E	Change of holes Ø9 by M8 for the fixation of protections rails. Add chamfer 5.	24/02/2021	DGO	EAP 85484 EAP 83830
D	Add 5 holes Ø 9	29/10/2014	CB	EAP 29545
C	Modif position hole Ø80	26/11/2012	DGL	EAP17963
B	Delete Ø9	06/02/2008	DG	EAP1922
A	Ajout de la découpe 180x10 / Addition of cutting 180x10	05/11/2007	DG	EAP1922
REV.	DESCRIPTION	DATE	Modified by	ECR
Tolérances générales Voir DMS : 080		MARQUAGE PIECE P/N + Rev		
Matière	S235J2	Masse (Kg)	Format	Ech.
Protection	Brut / Raw	64.3620	A3	1:10
TOLE INFÉRIEURE GAUCHE LEFT INFERIOR SHEET				
9409466		E02	1/3	
P/N		Rev.	Folio

9409466

DETAIL A

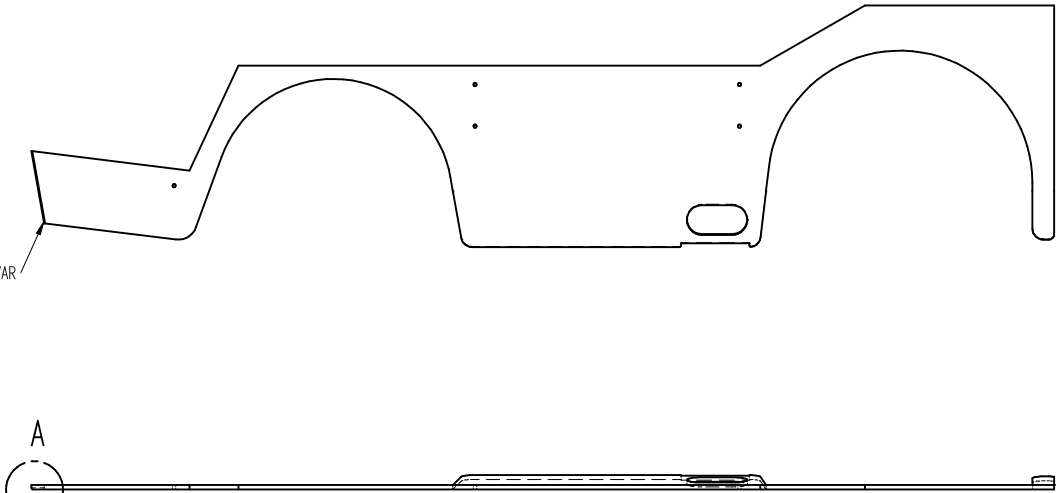
02 ZM/22/00288 - ÚPRAVA ÚKOSU NA 10x30°

SRAZIT HRANY PRO Y SVAR
